# Kit Instruction— KUDSCS0100

## KIT KUDSCS0100: CHANGE PRESS SLED DRIVE TO WELDED CLUTCH AND SLOW MOTOR

**APPLICABILITY:** Press models PRIOR to MP5031CL/ABP, MP5031CR/ABP, MP5031L/ABP, MP5031R/ABP (Presses manufactured prior to February 1988).

Figure 1 (MSSMD436AE)  
Press Sled Drive Assembly

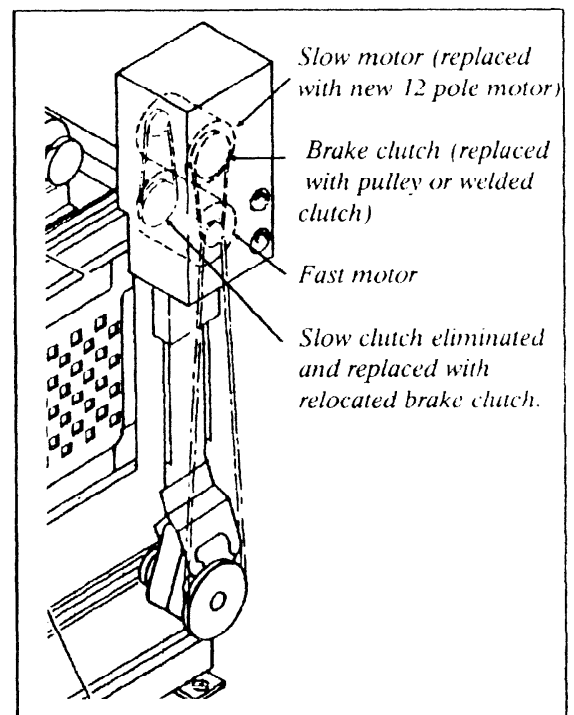
It has been found that after 9 to 18 months, the slow clutch can wear enough to cause the sled to hit its mechanical stop, in turn causing the torque arm switch to actuate and shutting the press down. Referring to Figure 1, Press models now in production use a new 12 pole slow motor (P/N 39T007AAU) that need not be disengaged, eliminating the need for a slow clutch. A welded clutch or fixed pulley is installed where the brake clutch was located and the brake clutch is now moved to where the slow clutch was located.

1. Replace/relocate mechanical components in accordance with Figure 1.
2. Compare the two schematics W6PRSMC and W6PRSMCA supplied with the kit. W6PRSMC reflects how the machine was wired to accommodate the old slow motor and slow clutch. W6PRSMCA is the schematic, for the new welded clutch and slow motor scheme. Note that on schematic W6PRSMC the slow clutch circuitry (lines 02-04) is no longer used.
3. Reroute the output of the brake rectifier to correspond with the new physical location of the brake clutch.
4. Wire the auxiliaries of the sled fast contactor CSRFR and CSFFL (line 07) as shown on schematic W6PRSMCA.
5. Wire the brake safety override switch SHSC into the circuit as shown on line 08 and line 14 of schematic W6PRSMCA.
6. Run the Press manually, checking for proper operation, pulley alignment, etc., again locking power off to make any necessary adjustments.
